**515 Drewry Avenue – Zoning By-law Amendment and
Site Plan Control Applications – Final Report**

Date:	June 18, 2008
To:	North York Community Council
From:	Director, Community Planning, North York District
Wards:	Ward 23 – Willowdale
Reference Number:	07 264632 NNY 23 OZ

This application proposes to demolish the existing gas pump island and kiosk, convenience store and auto service building, and construct a new convenience store, gas pump island and stationary car wash at 515 Drewry Avenue.

Attachment 1: Site Plan

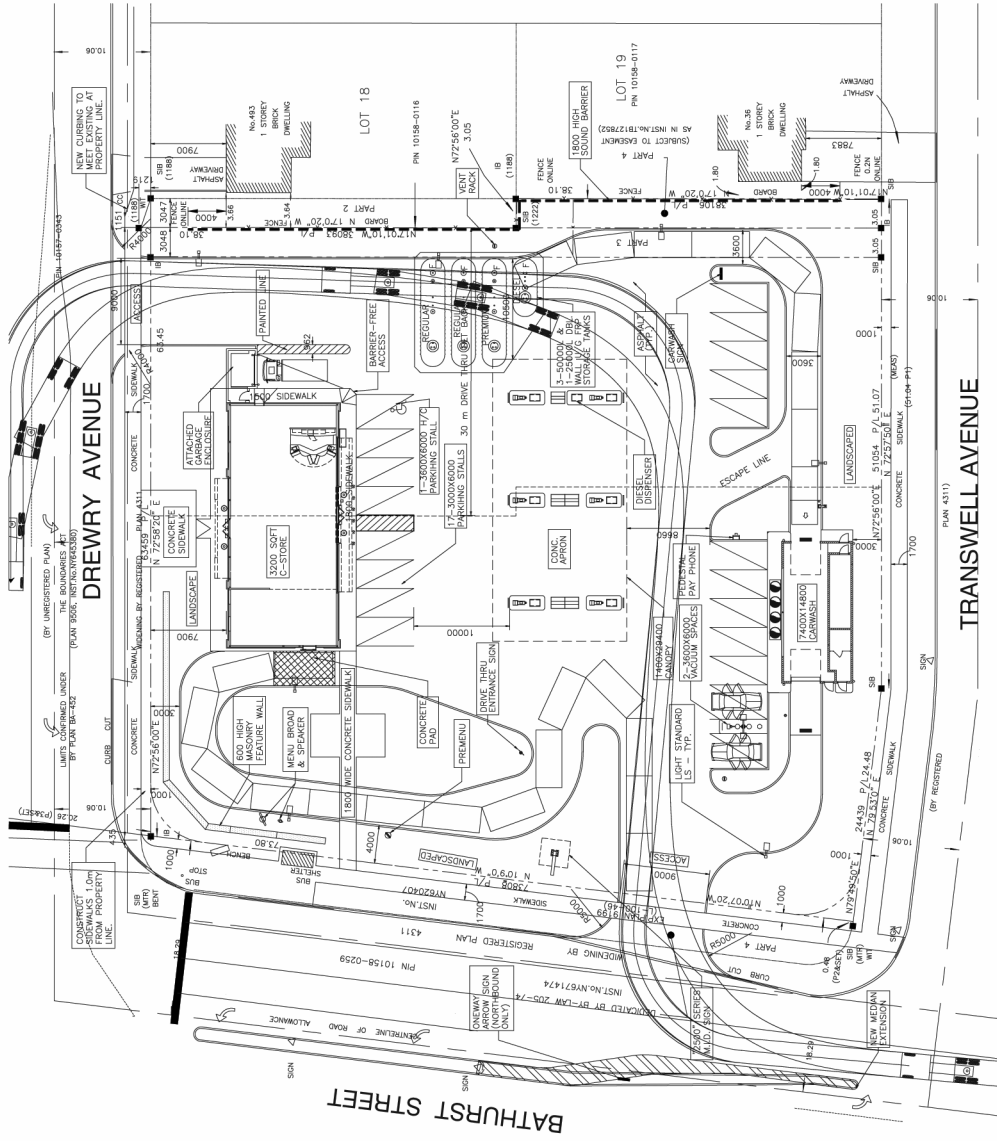
The applicant is also proposing to provide 18 parking spaces for the convenience store portion of the development, and two vacuum spaces for the proposed car wash. This satisfies the minimum parking requirement for the subject site. However, the By-law requires one disabled parking space having a minimum width of 3.65 metres. The applicant will be required to provide revised drawings that provides for this disabled parking space.

The submitted landscape plan shows that the applicant is proposing to plant 5 new trees within the public boulevard on Transwell Avenue. As a condition of Site Plan Approval, Urban Forestry Services requires that the applicant submit revised site plans showing one additional street tree to be planted within the City road allowance along Bathurst Street.

9. As per our previous comments, a disabled parking space must have a minimum width of 3.65 metres (as per By-law 31770). The applicant must show this on the revised site plan.
10. The owner shall deposit with the Technical Services Division prior to Site Plan Approval, certified cheques, for the following;
- a) Reconstruction of a 1.7 metre wide sidewalk across the entire Drewry Avenue frontage of the site to the location of 0.5 metre from the property line. In addition, the reconstruction of a 1.7 metre wide sidewalk across the entire Bathurst Street and Transwell Avenue frontages of the site to the standard location of 1.0 metre from the property line. The cost of this work is estimated to be \$57,600.00.
 - b) \$3,024.00 representing the 5% Engineering review fee of the above construction works.
